STAFF REPORT: 7-24-2019 MEETING
APPLICATION NUMBER: 19-6354
ADDRESS: 3000 SEMINOLE
HISTORIC DISTRICT: INDIAN VILLAGE
APPLICANT: CAL GARFIELD
DATE OF STAFF VISIT: 5-28-2019

PREPARED BY: J. ROSS

BREAKFAST NOOK ADDITION
3000 Seminoles Street
Detroit, MI 48214

3000 Seminole. Front elevation (top photo) and rear elevation (bottom photo)

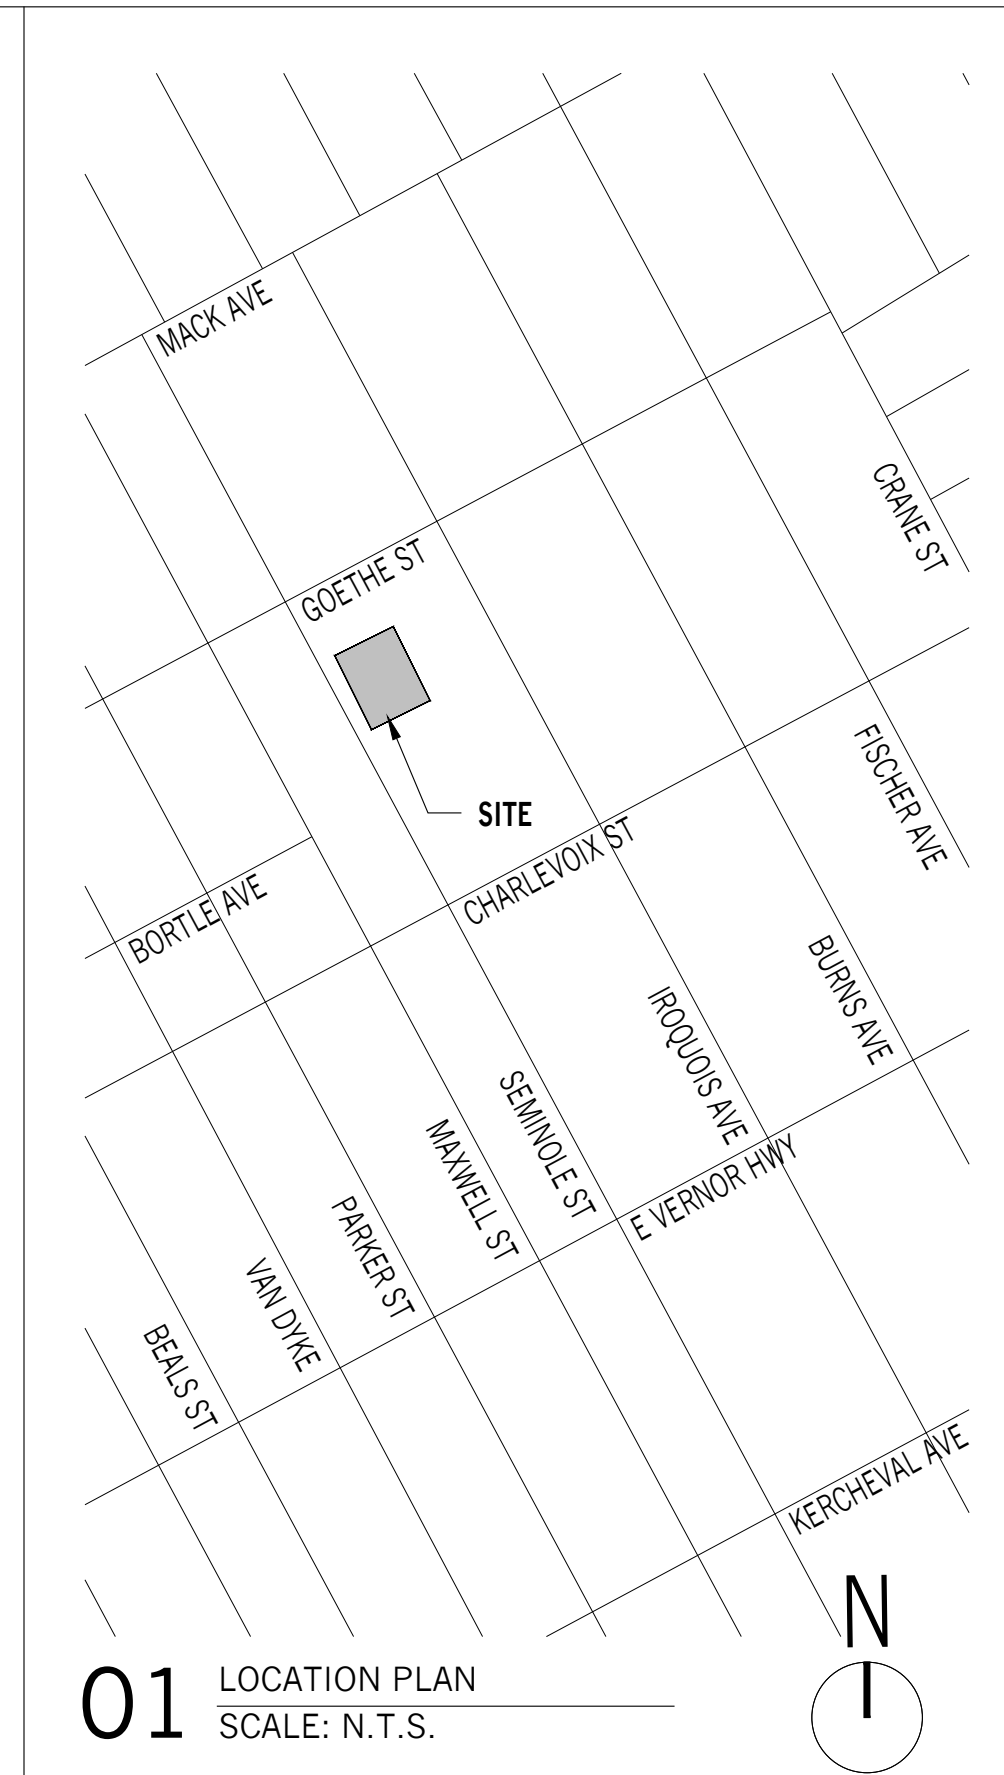
Erected ca. 1923, the resource located at 3000 Seminole is a 2 ½-story, single-family dwelling that is located within the Indian Village Historic District. Exterior walls are primarily clad with red brick. Wood siding appears at the rear elevation. Windows are 6/6, double-hung units and decorative shutters at the front elevation.

EAST ELEVATION

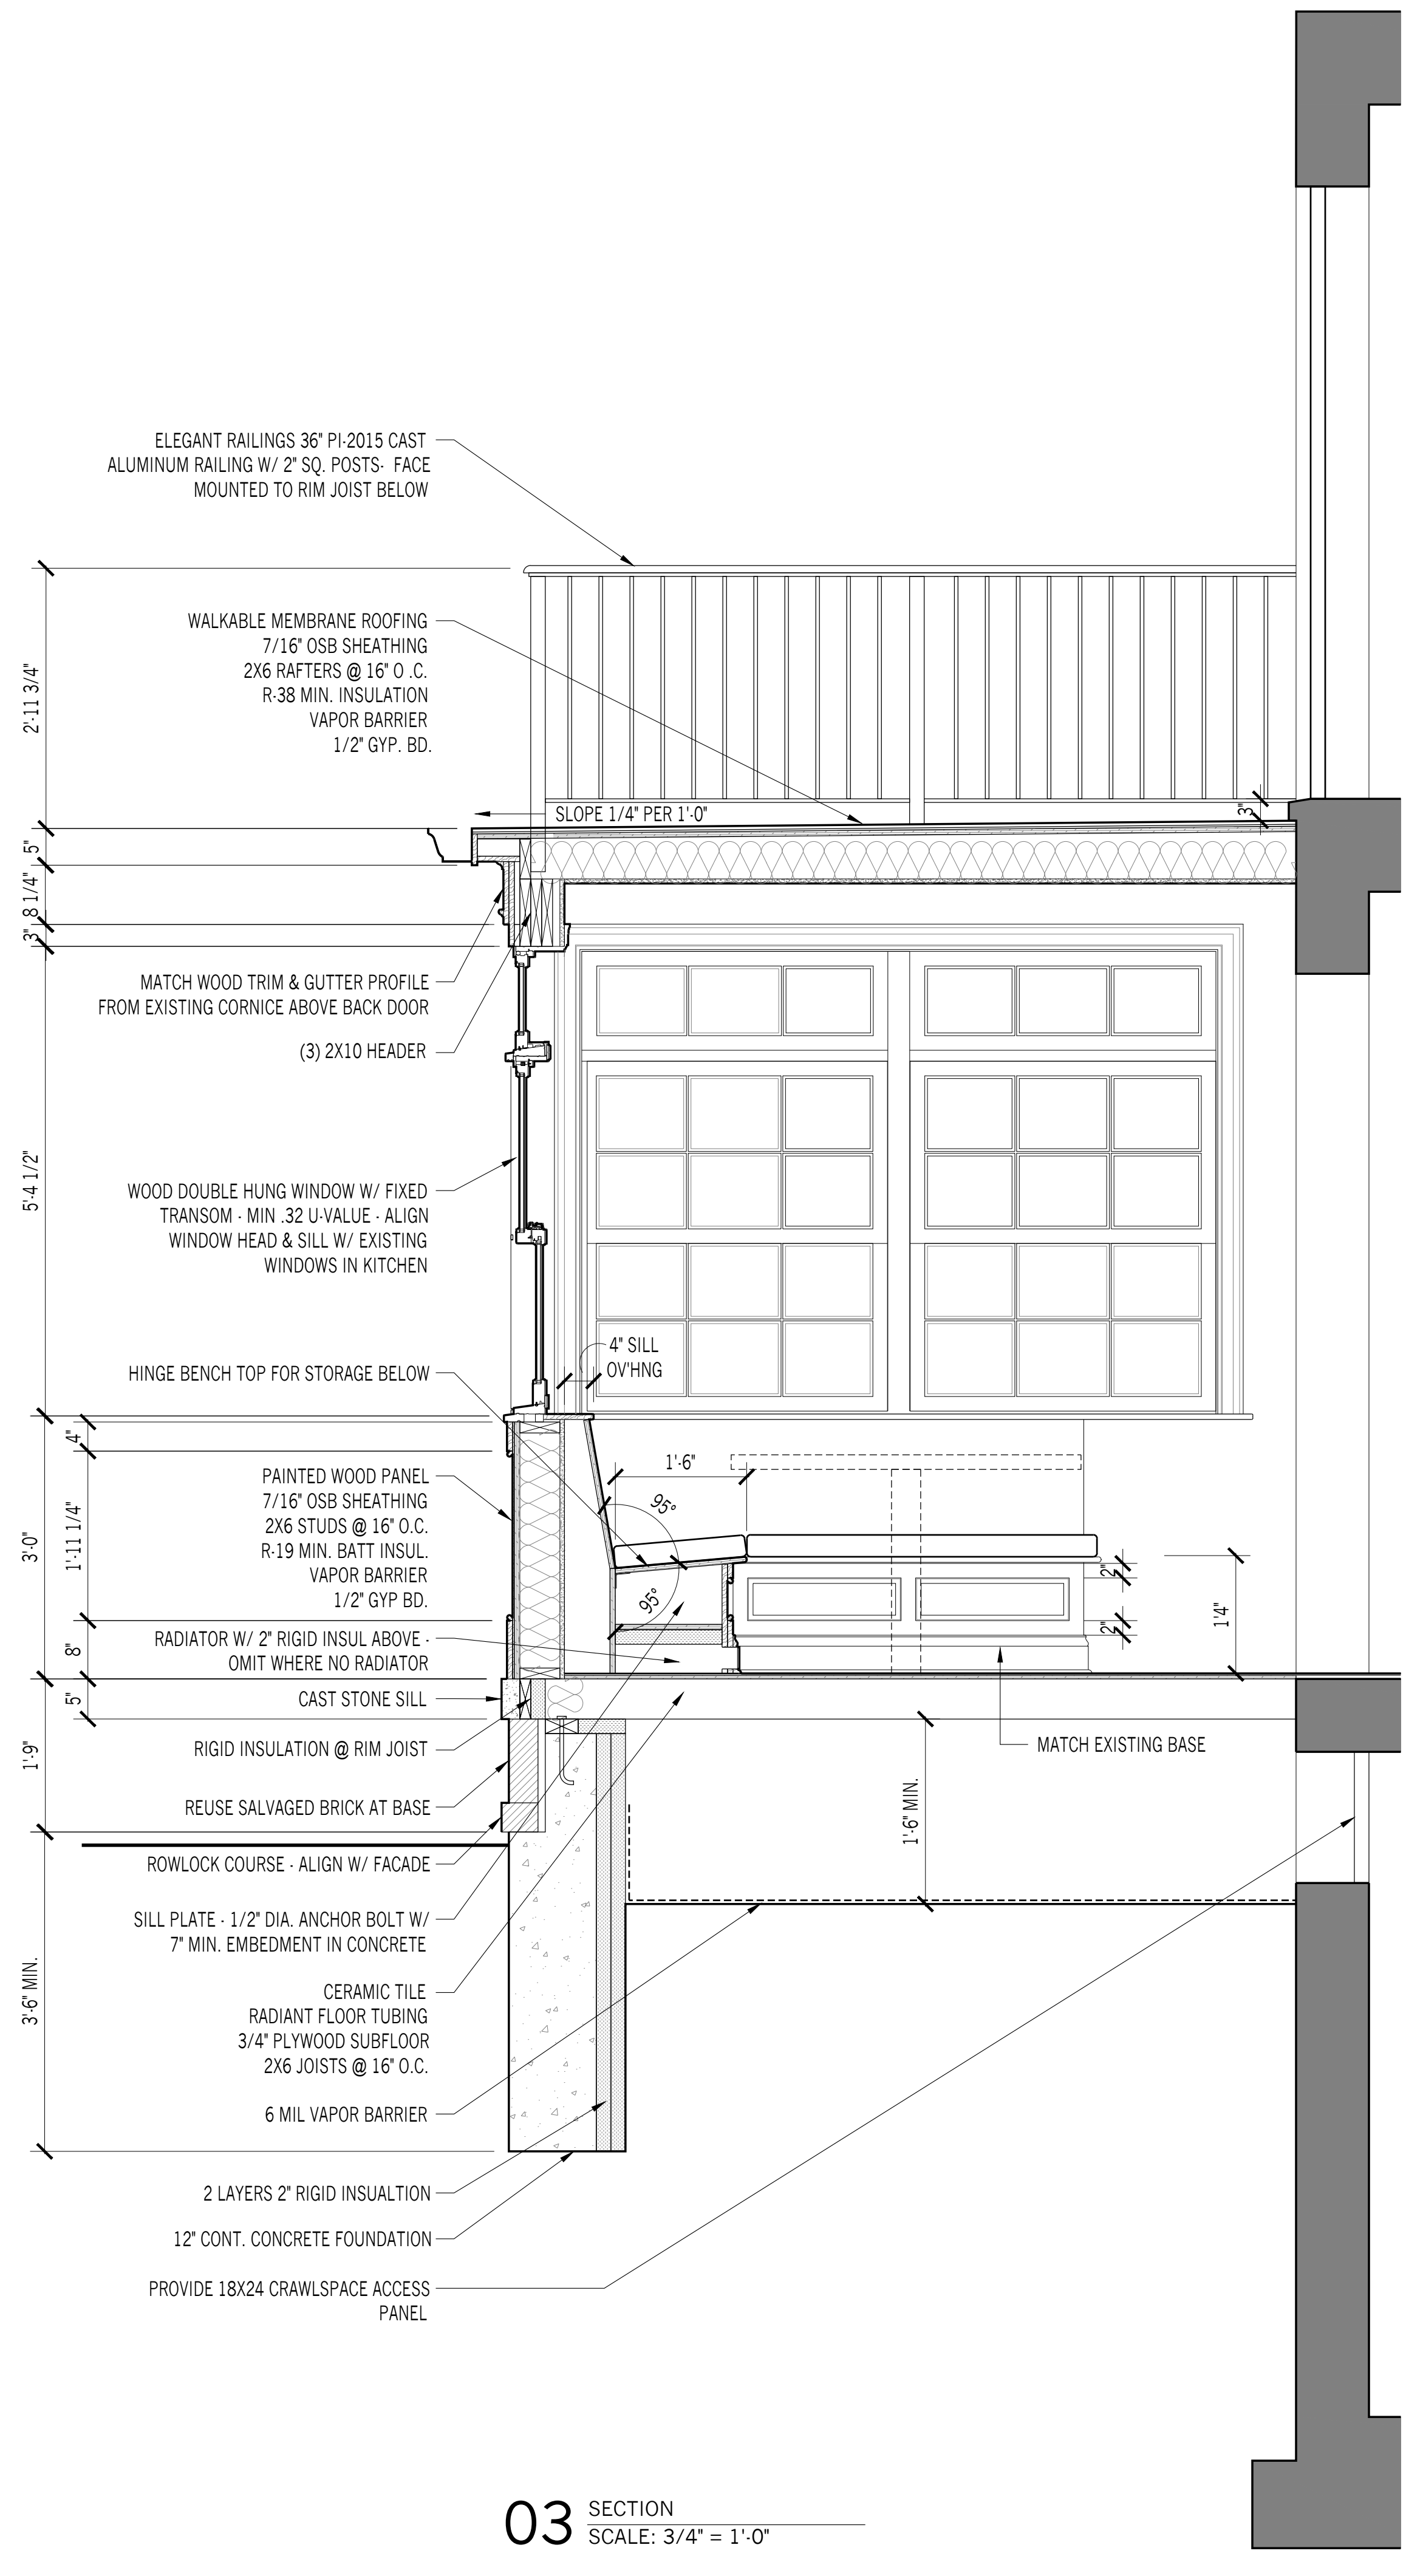
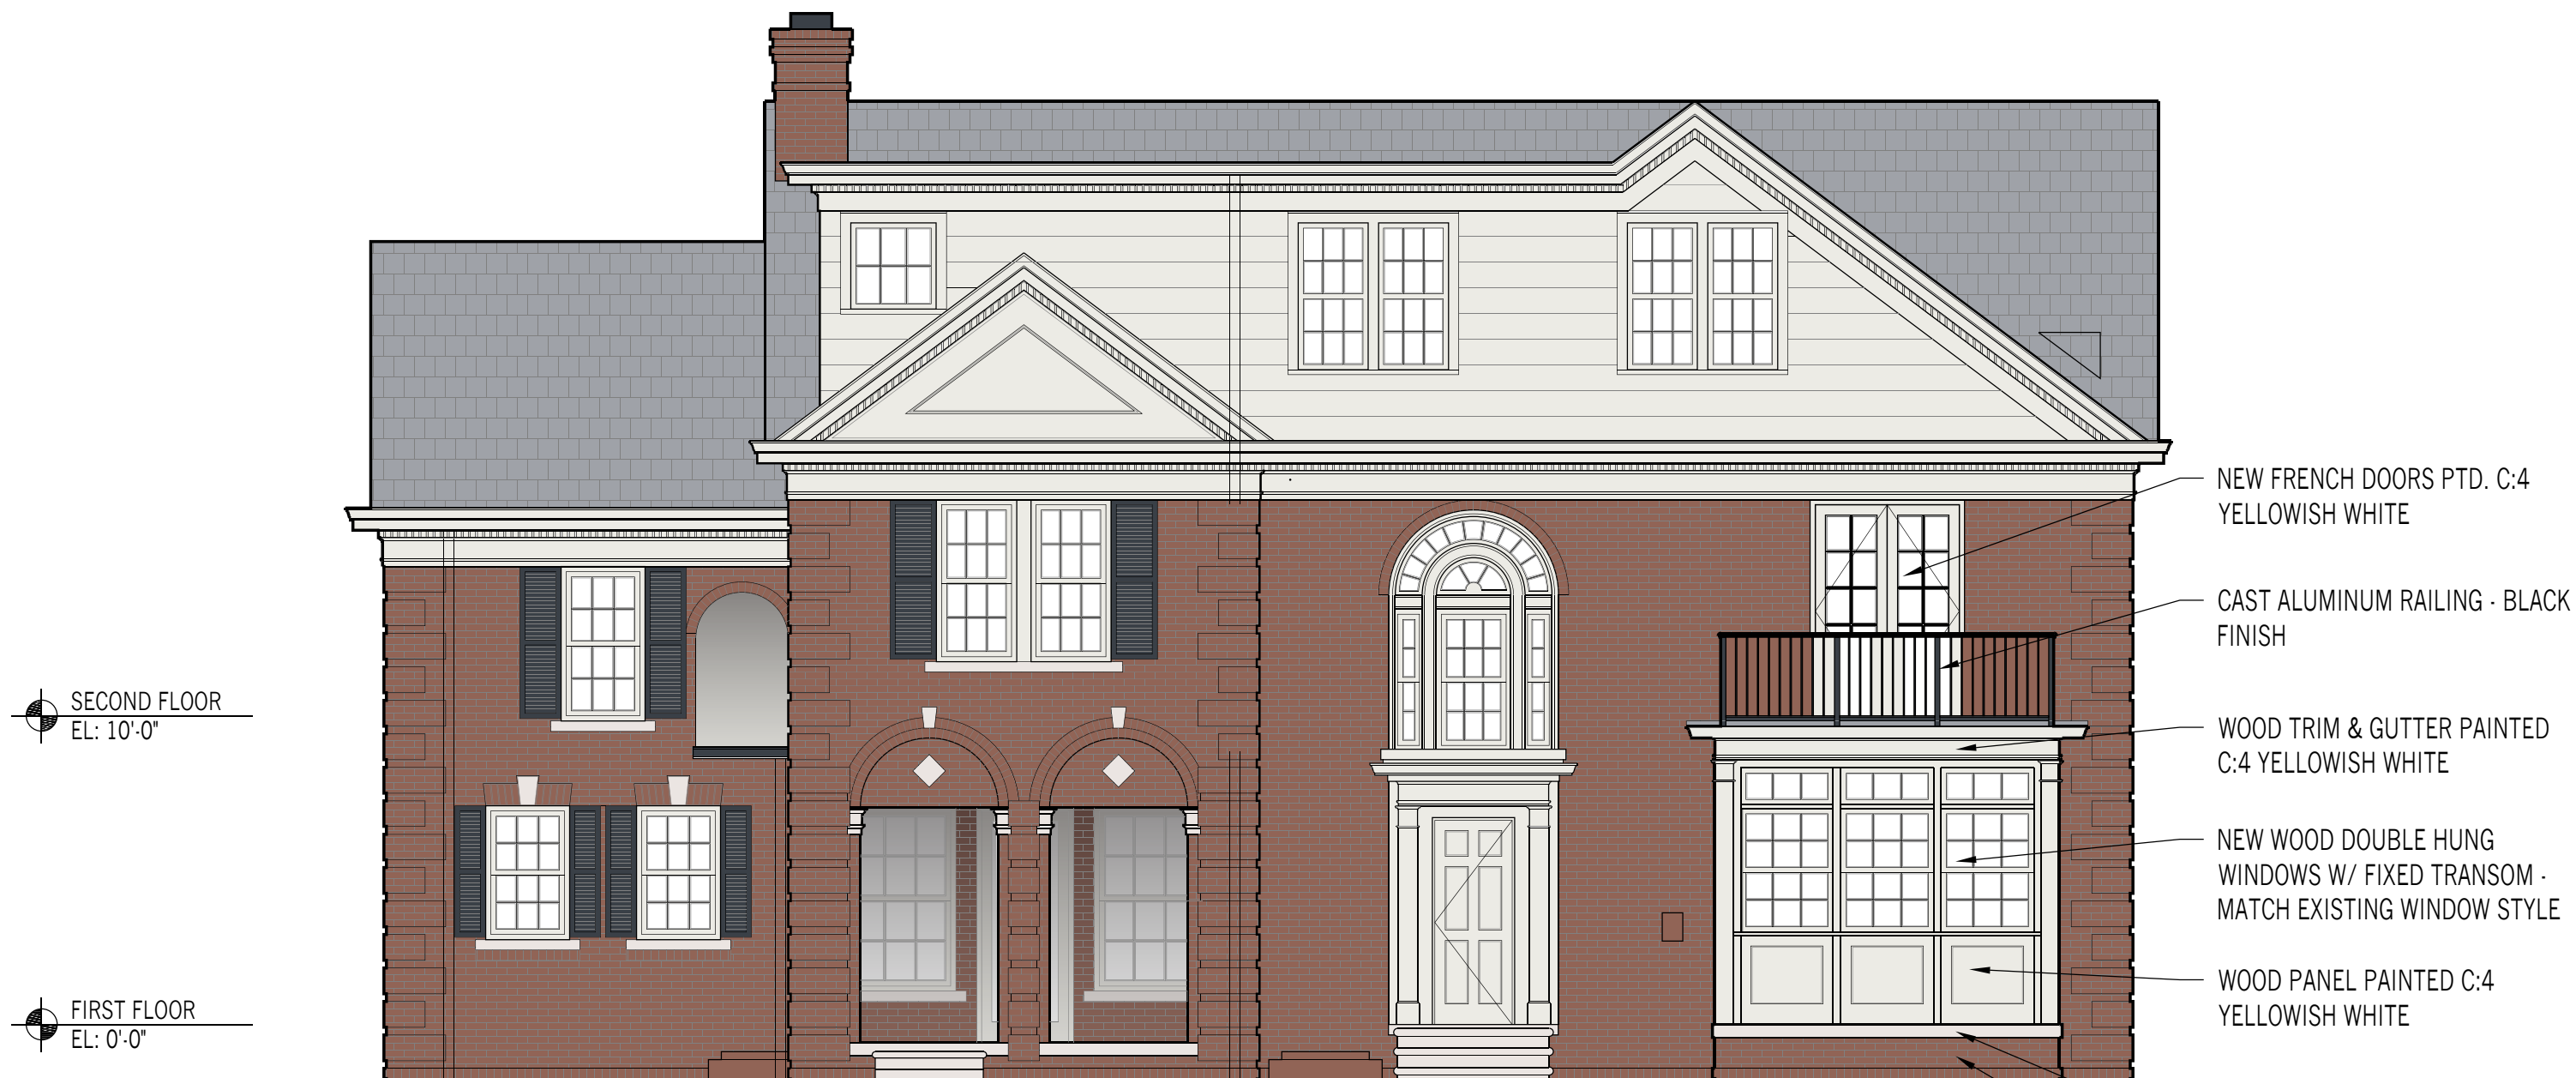
Rear/East Elevation

- Remove existing window well,
- Erect a new “breakfast nook” addition at the rear elevation. The footprint will measure 9’-6” x 12’-2”. The addition will feature double-hung wood windows, wood trim Painted yellowish white), and a salvaged brick kneewall. The roof will be topped with aluminum railing and will function as a deck/second- story porch.
- At the location of the new second-story porch, remove the existing window (salvage window), expand opening and install a set of French doors (material no specified)

It is staff’s opinion that the proposed new addition is compatible with the massing, size, scale, and architectural features of the historic home. Furthermore, the use of wood siding marks the wing as new/differentiates it from the original fabric.

It is staff's opinion that the proposed new addition is compatible with the massing, size, scale, and architectural features of the historic home. The use of wood siding marks the wing as new/differentiates the addition from the original fabric. Additionally, the lengthening of the side elevation window, the addition of a set of French doors at the second story, and the proposed sitework will not result in the removal of historic materials or alteration of features and spaces that characterize a property. Staff therefore recommends that the Commission issue a Certificate of Appropriateness (COA) for the proposed project because it meets the Secretary of the Interior's Standards for Rehabilitation, Standard number 2). The historic character of a property shall be retained and preserved. The removal of historic materials or alteration of features and space that characterize a property shall be avoided and 9). *New additions, exterior alterations or related new construction will not destroy historic materials, features and spatial relationships that characterize the property. The new work will be differentiated from the old and will be compatible with the historic materials, features, size, scale and proportion, and massing to protect the integrity of the property and its environment*
